Product / Process Change Notification (PCN)

PCN #: PCN_WL-SBCW_20190914

Affected Series: WL-SBCW

DESCRIPTION AND PURPOSE OF CHANGE:

Dimensions of 150066SV7400 and 150066YV7400

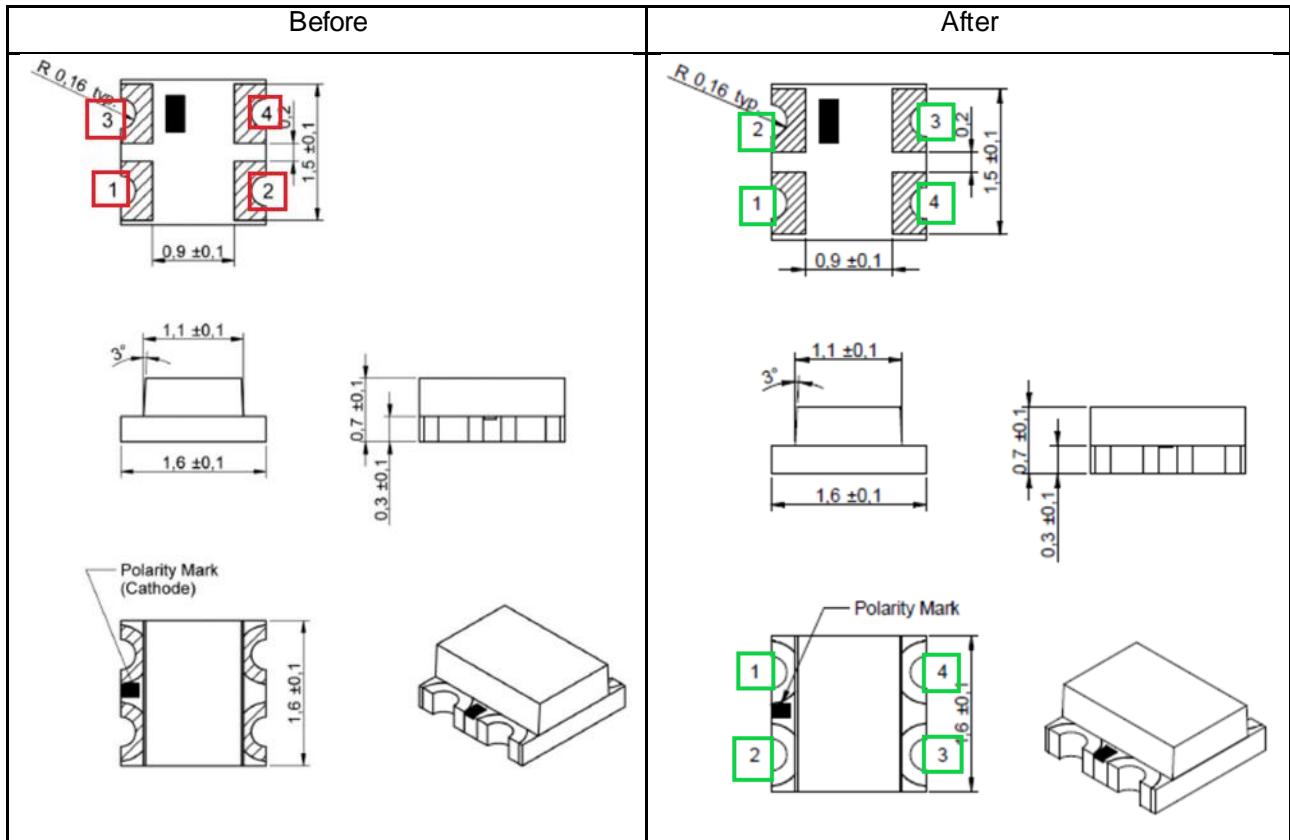
1. Pin numbering of dimensions drawing
2. Pin numbering of land pattern
3. Pin numbering and symbol of schematic
